CONTRACT NO: 009805 FEDERAL AID NO: NHPP-0051 (314)
 CONTRACT TITLE: I- 5 DIKE ACCESS W, BR MP 22.7 & BNRR BR PAINTING
 CHANGE ORDER NO: 1 FULL ABRASIVE BLAST 5-105W

This change deletes bid item 04, Cleaning and Painting Paint Bridge 5/105W and creates a new bid item to provide compensation to the Contractor for the full abrasive blasting and painting of Bridge 5/105W. In addition, plan sheet 12, BB1 is modified according to page 4 of this change order.

1-5
DIKE ACCESS W BR MP 22.7
AND BNRR BR MP 26 - PAINTING
BR. NO. 5/105W

BRIDGE SHEET NO. BB1
SHEET 12 OF 21 SHEETS

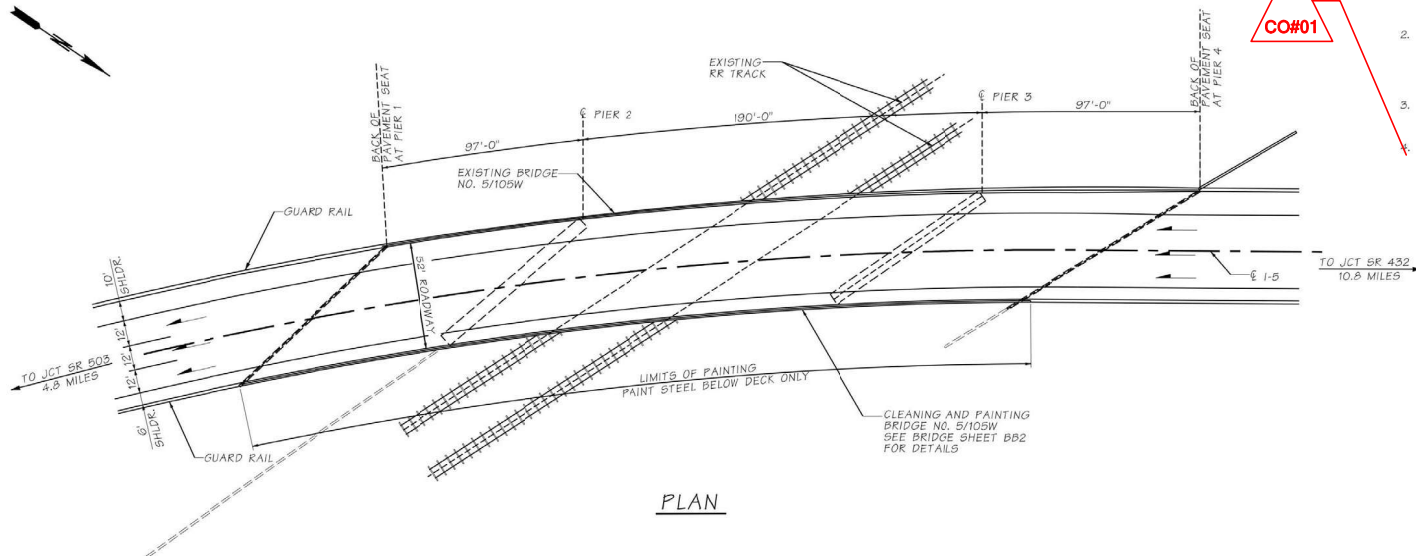
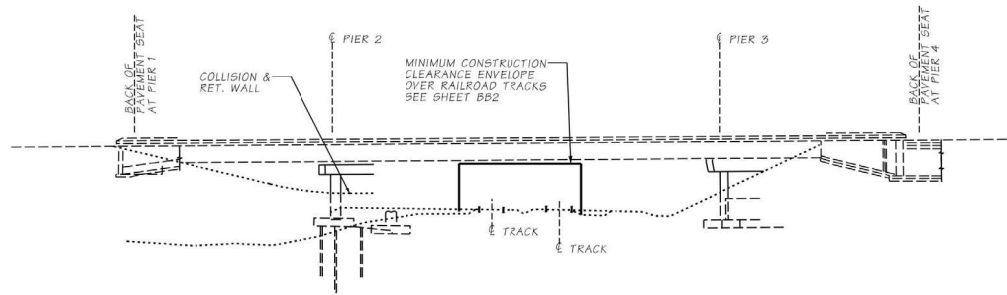
Surface Preparation - Full Paint Removal
Full removal of existing paint is specified for 5/105W. The Contractor shall remove any visible oil, grease, and road tar in accordance with SSPC-SP 1. Following preparation by SSPC-SP 1, all steel surfaces to be painted, and any areas needing treatment of pack rust and gaps, shall be prepared in accordance with SSPC-SP 6, Commercial Blast Cleaning. Surfaces inaccessible to Commercial Blast Cleaning shall be prepared in accordance with SSPC-SP 11, Power Tool Cleaning to Bare Metal, as allowed by the Engineer.

New item, "CO1 Cleaning and Painting Paint Br 5-105W" shall meet the requirements of section 6-07.3, Construction Requirements. The surface preparation shall be according to Section 6-07.3(10)E Surface Preparation Full Paint Removal to a level of cleanliness according to SSPC-SP6 in lieu of SSPC-SP10. In addition, this item will meet the requirements of section 1-10, Temporary Traffic Control.
